## FCC CIIPC Declaration

FCC ID: 2APB2LIME-V3-US

We, **Neutron Holdings, Inc.**, hereby declare that we are only and fully responsible for this CIIPC application of FCC ID: **2APB2LIME-V3-US**, originally granted on **2018/11/28**. Now we would like to modify the authorized equipment for upgrading hardware to HW: V1.04 from V1.02 and upgrading software version to SW: S\_CCU\_FW\_AP\_E\_O\_MEIG\_V2\_1.0.10 from S\_MEIG\_V2\_AP\_U\_O\_1.0.2, the differences listed as below:

### E UART 5V

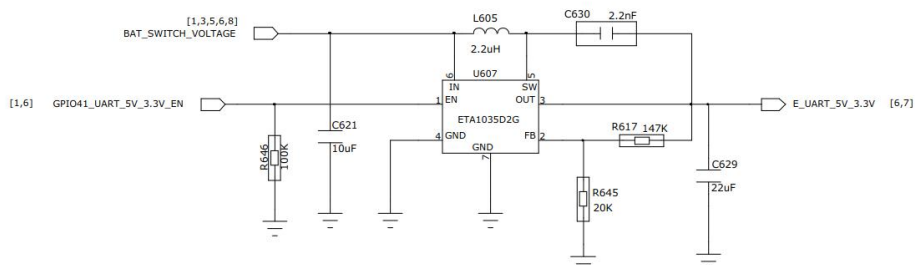
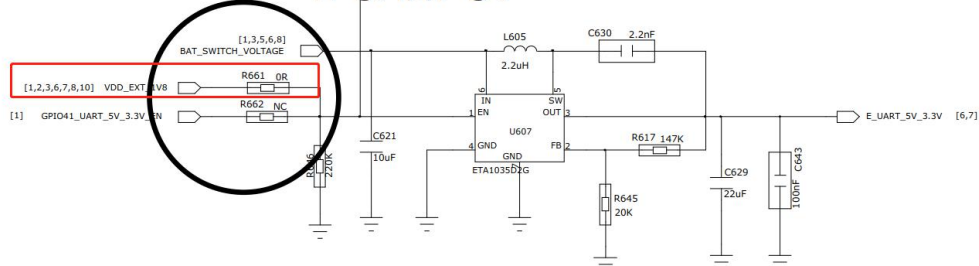
1. V1.04 version electronic power circuit use VDD\_EXT\_1V8 directly;

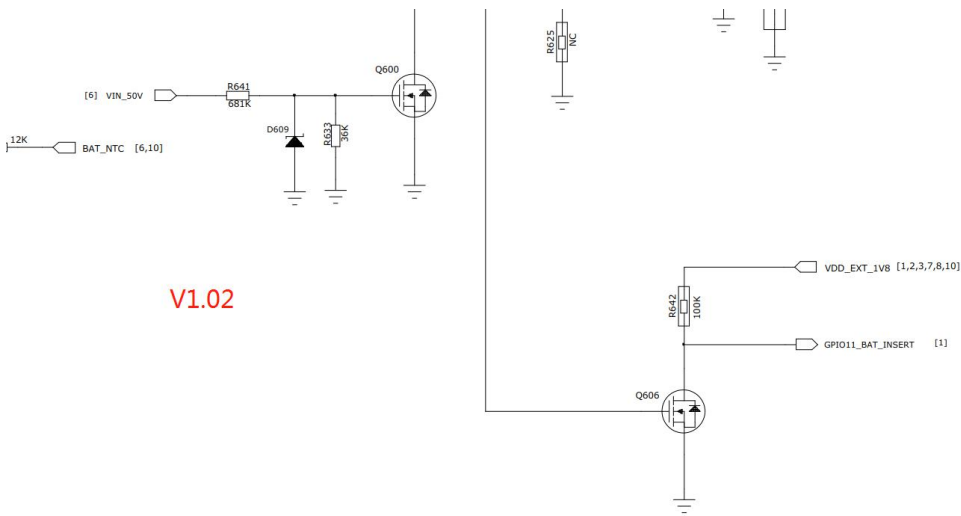
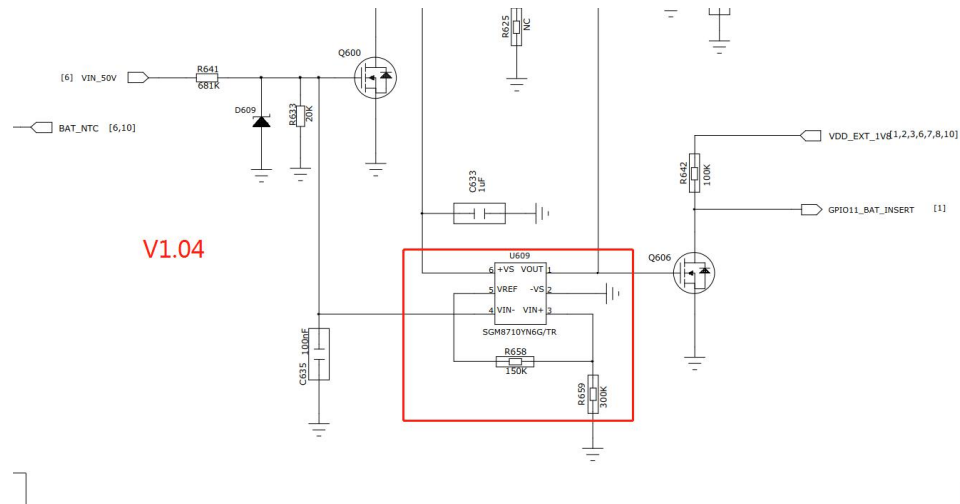
2. Remove some redundancy circuit as below base on V1.02 version;

## MCU POWER& MCU UART 5V

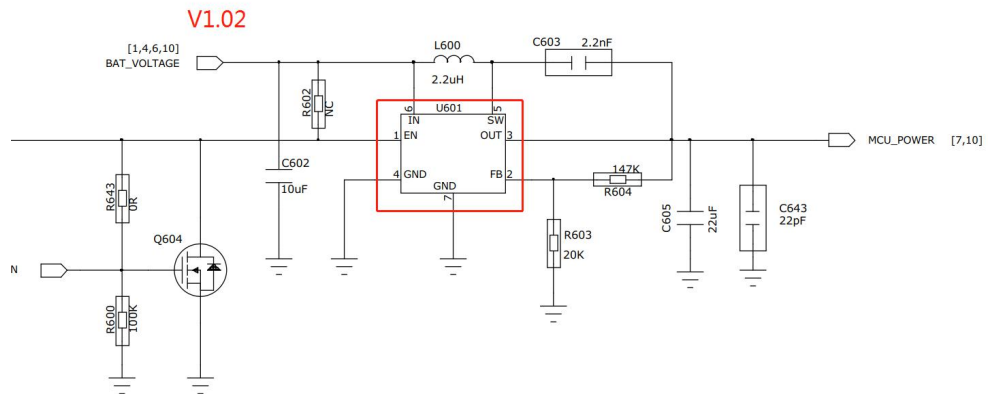
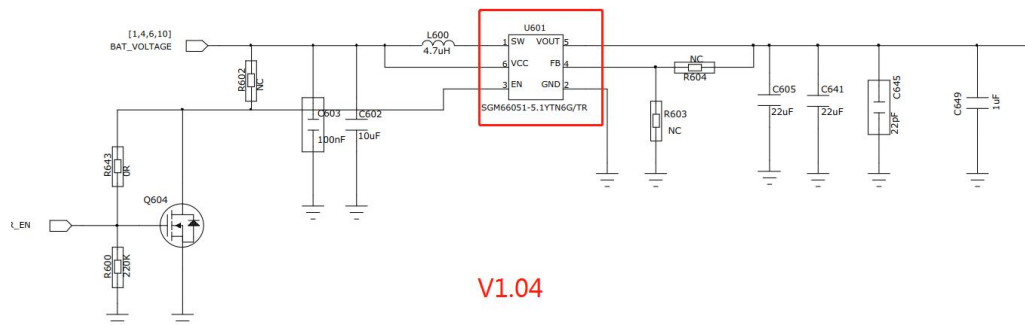
4. Change MCU UART 5V power supply chip;
